**ROCK HARBOR COMMERCIAL WHARF IMPROVEMENTS
TOWNS OF ORLEANS, MA
ADDENDUM #3**

PROJECT: Rock Harbor Commercial Wharf Improvements

DATE: March 22, 2024

CONSULTING ENGINEER: Foth Infrastructure & Environment, LLC
15 Creek Road, Marion, MA 02738

PUMPOUT STATION FENCE
 SCALE: 1" = 1'

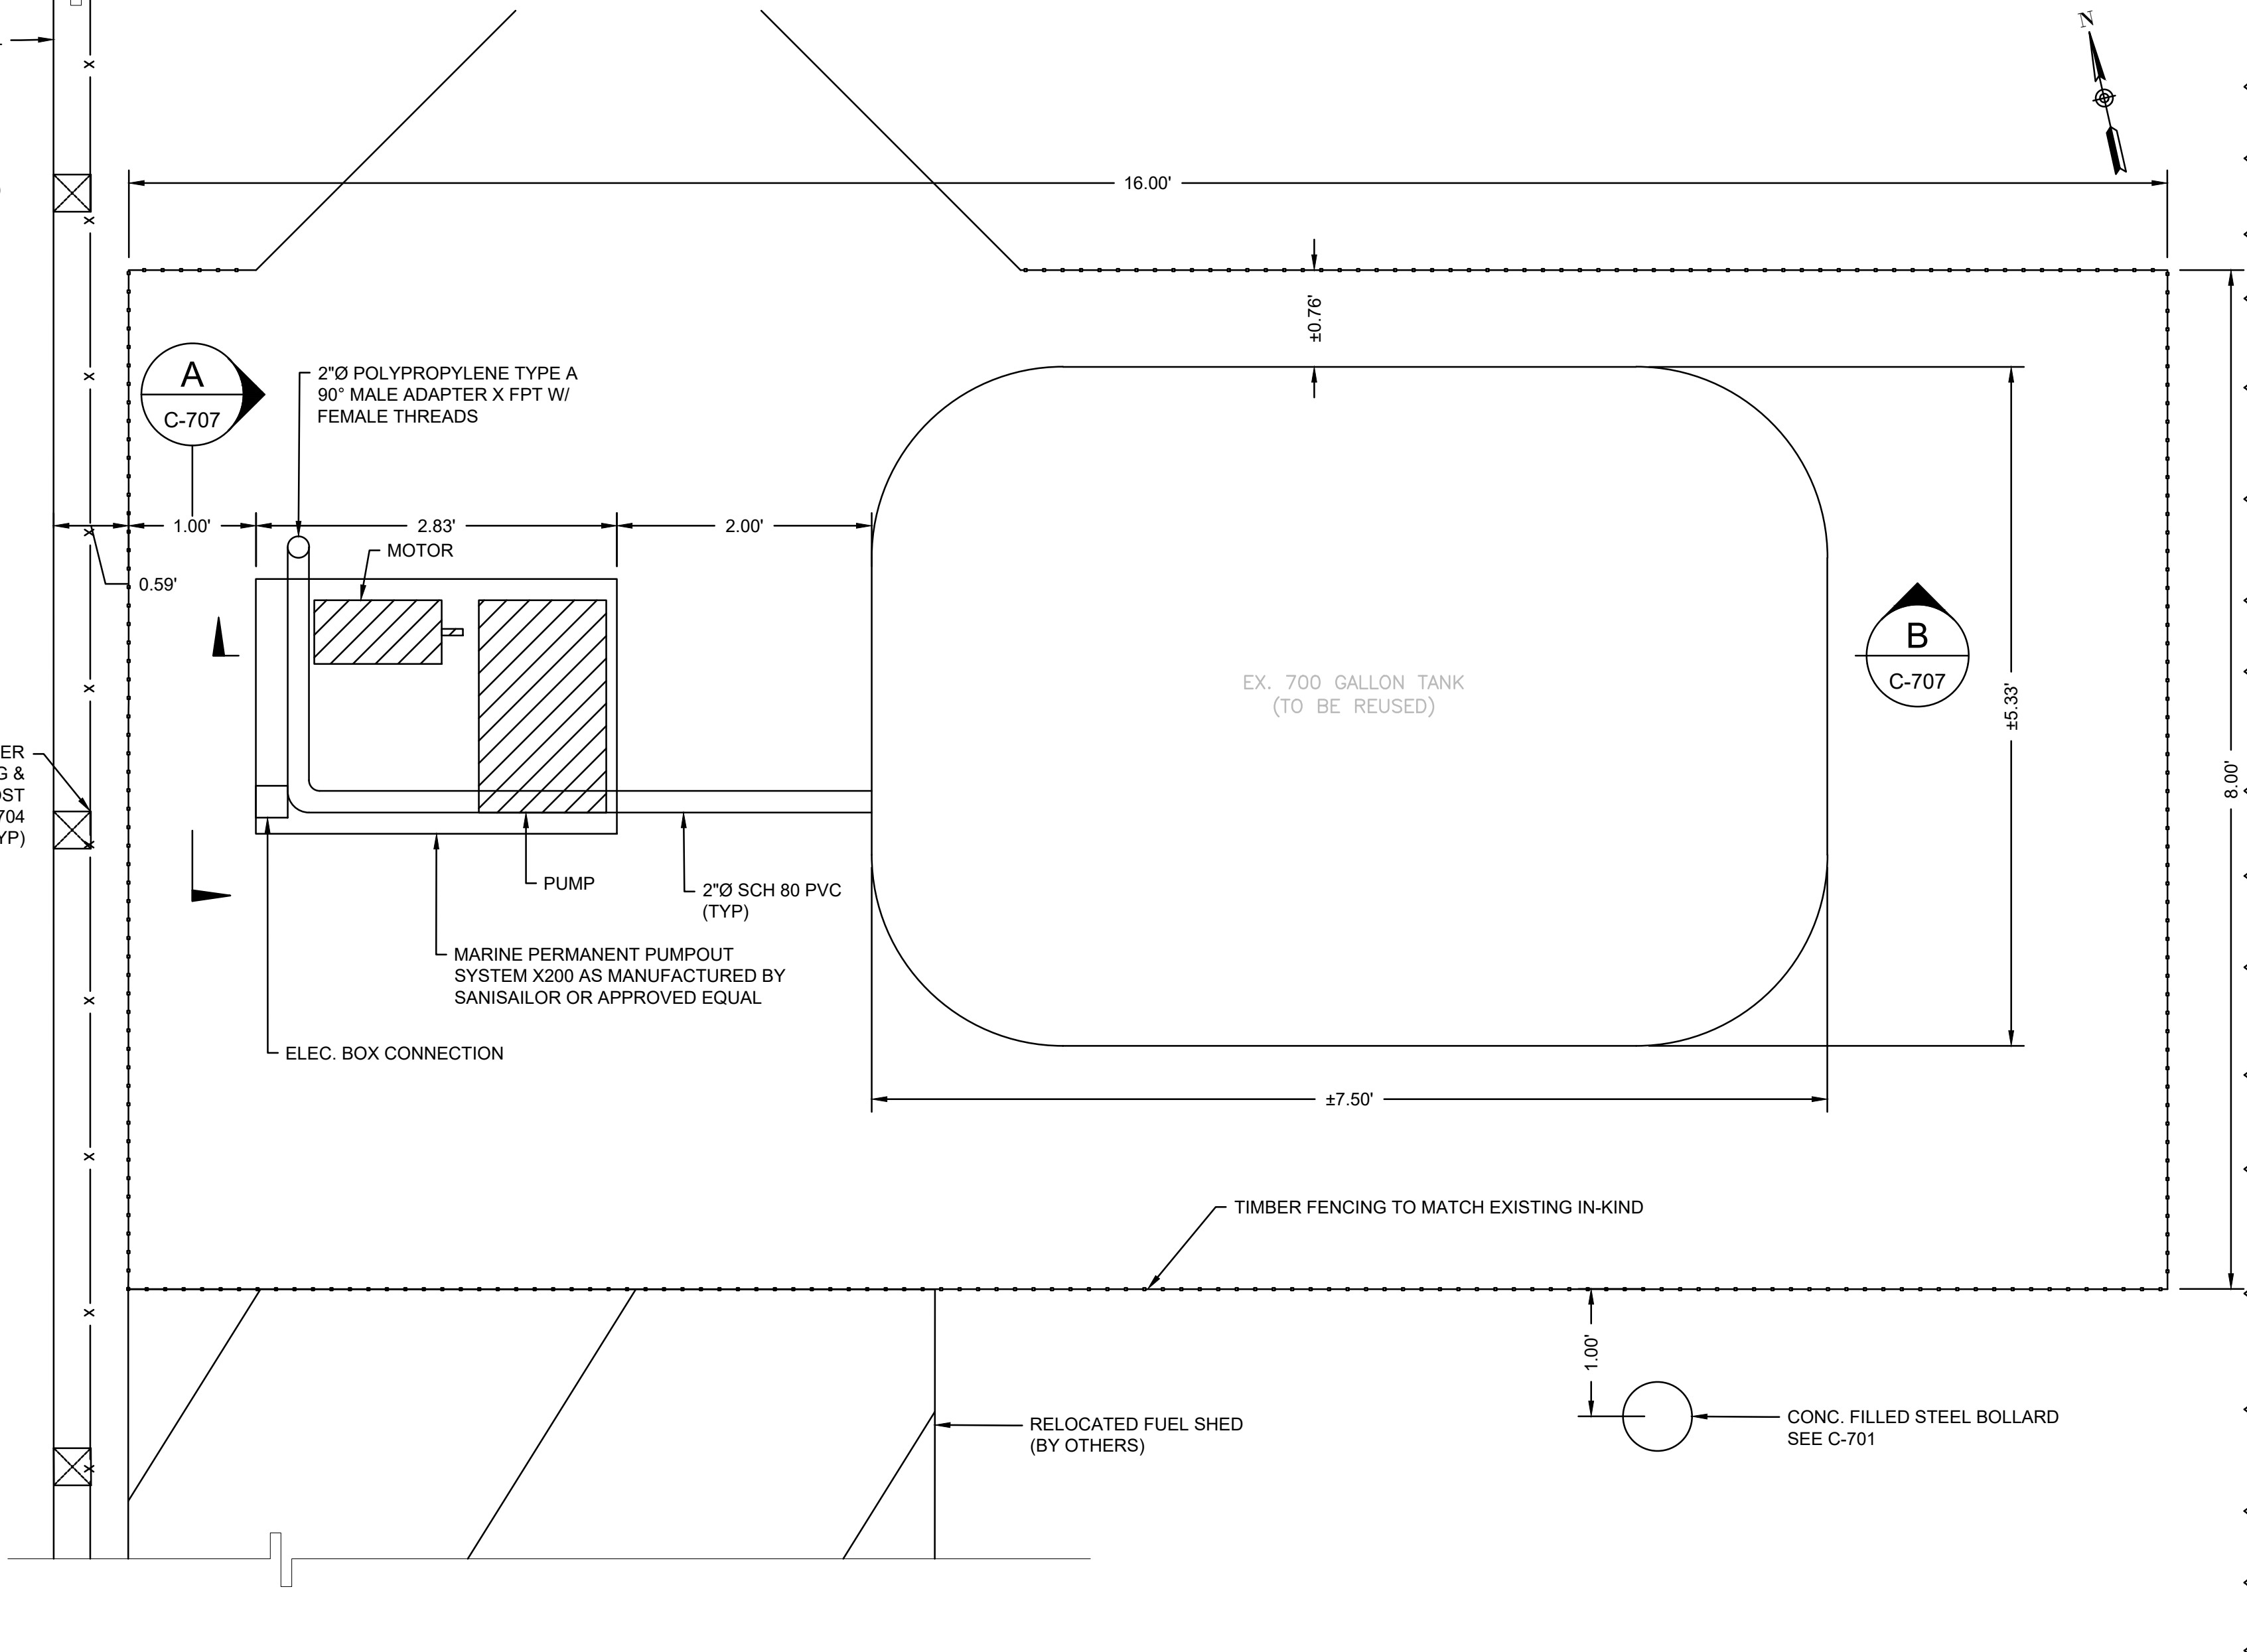
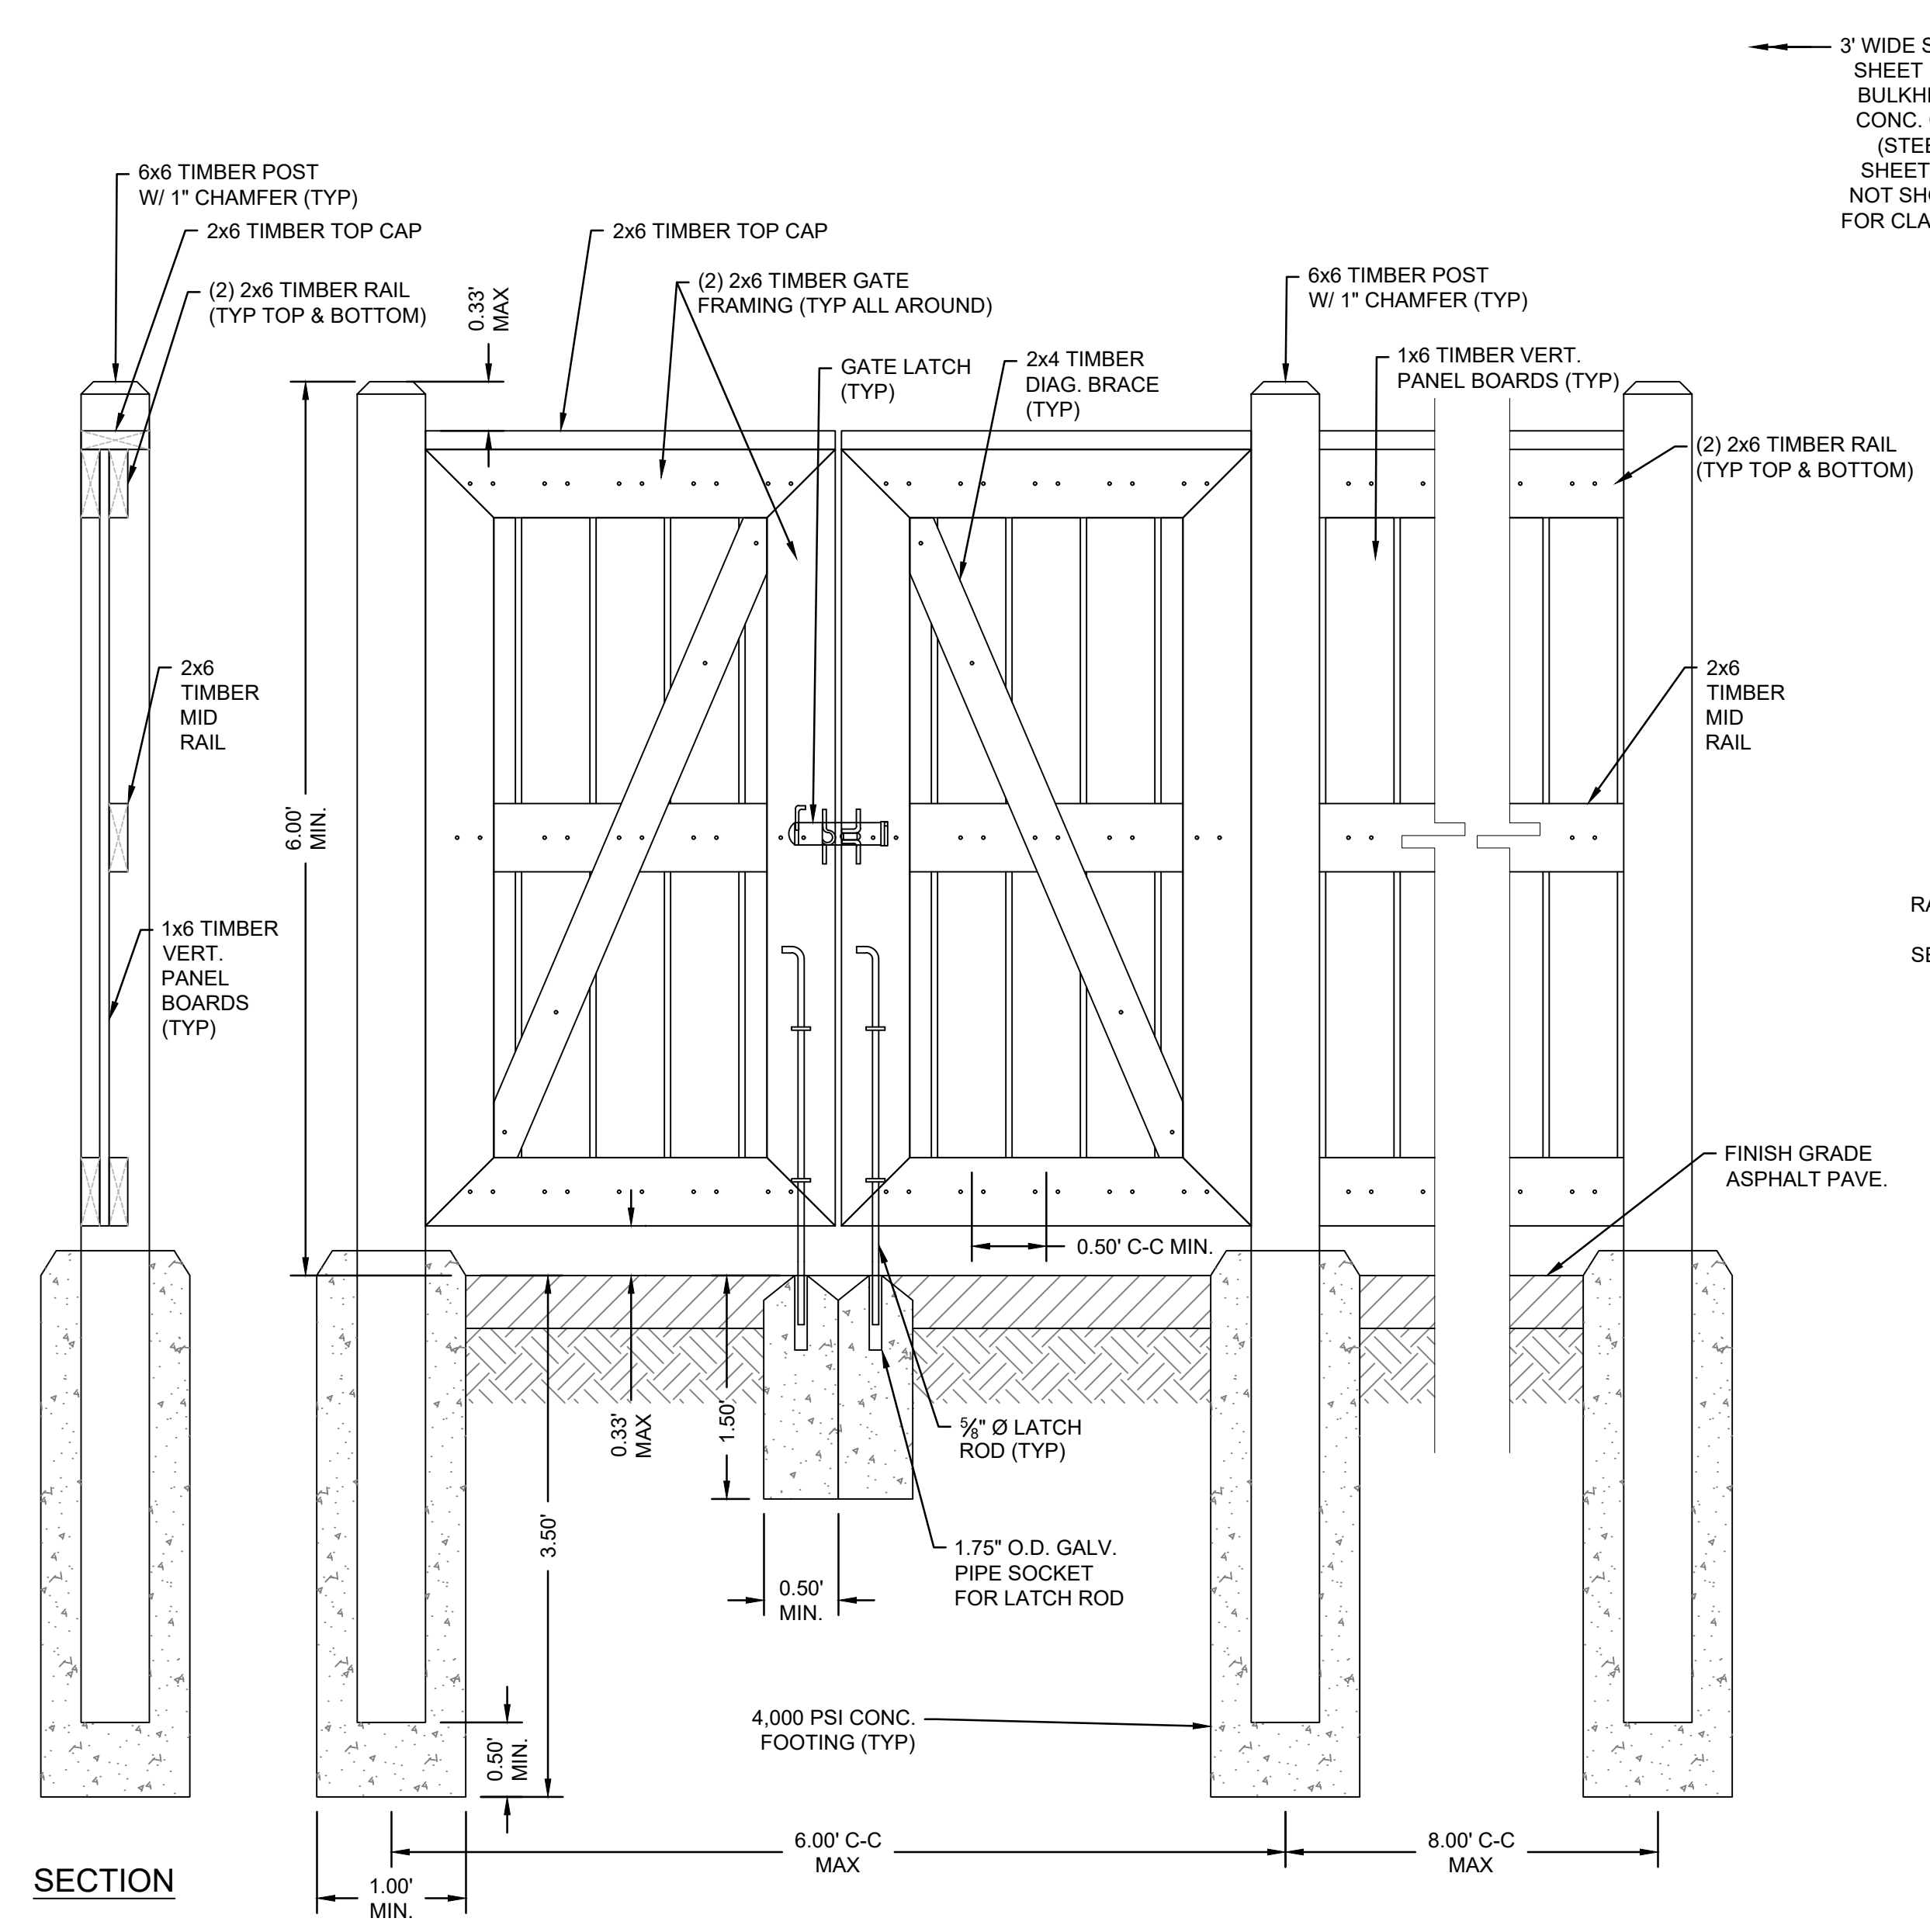
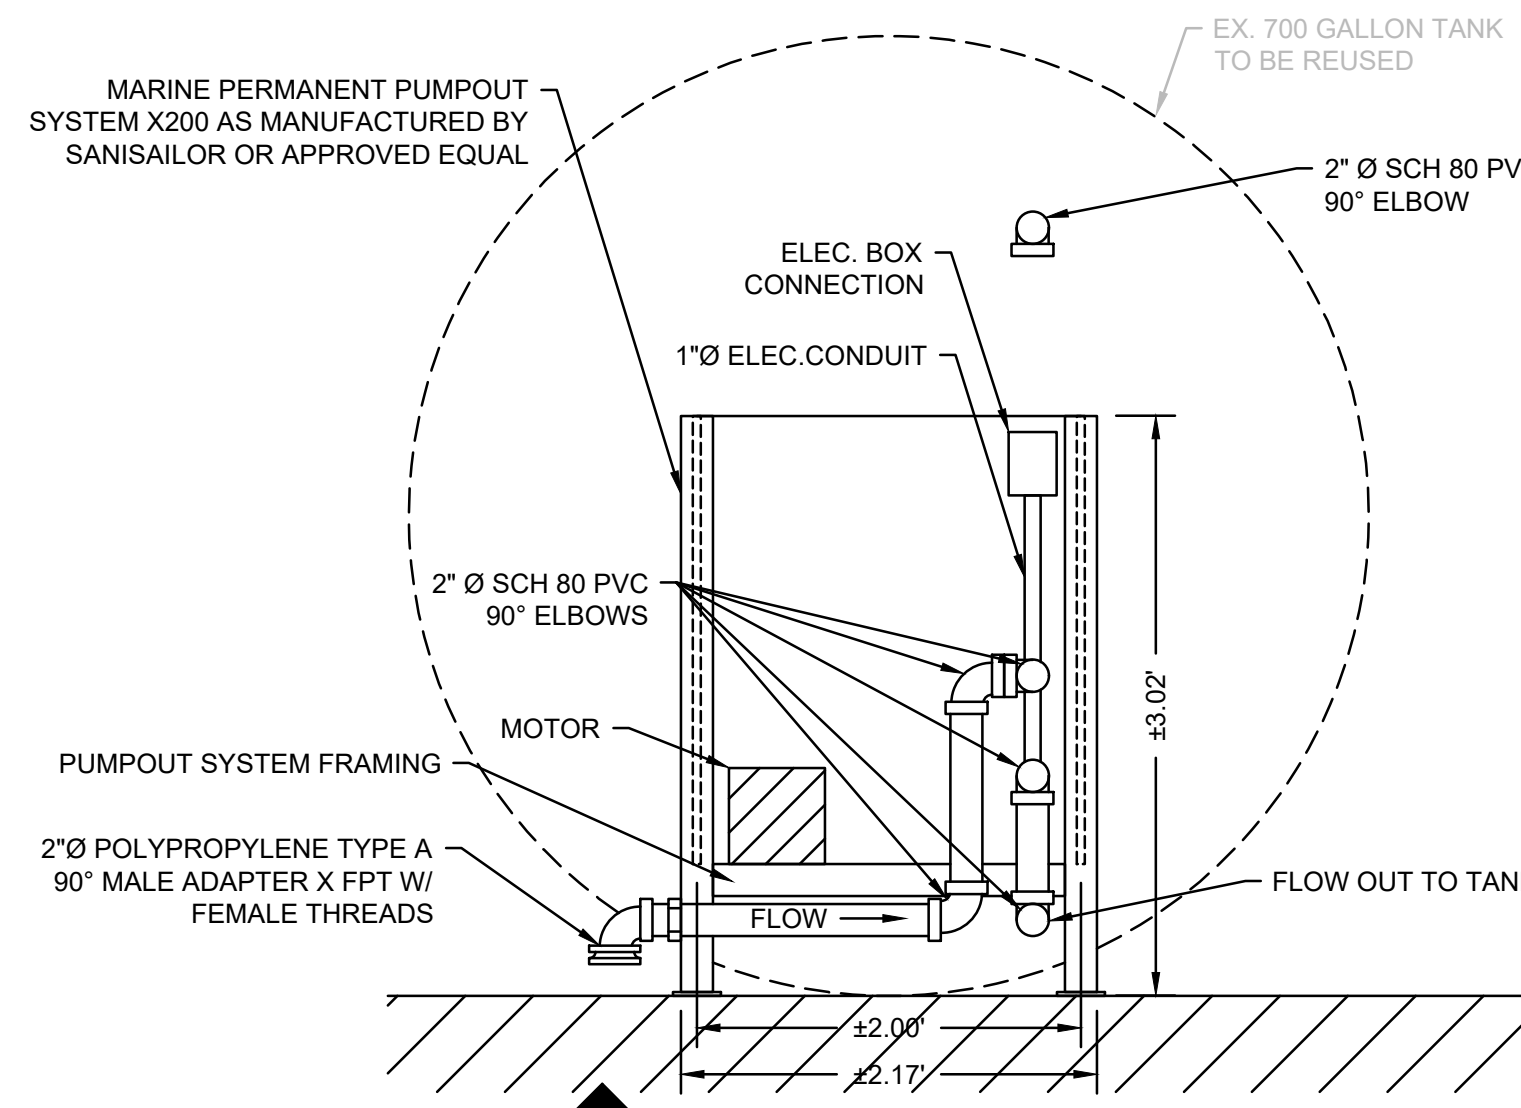
17. *Drawing C-202 shows some fence & gate at the relocated pump station location. Please advise whether this is a new timber fence. If so, please provide details of this timber fence & gate.*

RESPONSE: See sheet C-707 attached herein for new timber fence and gate detail.
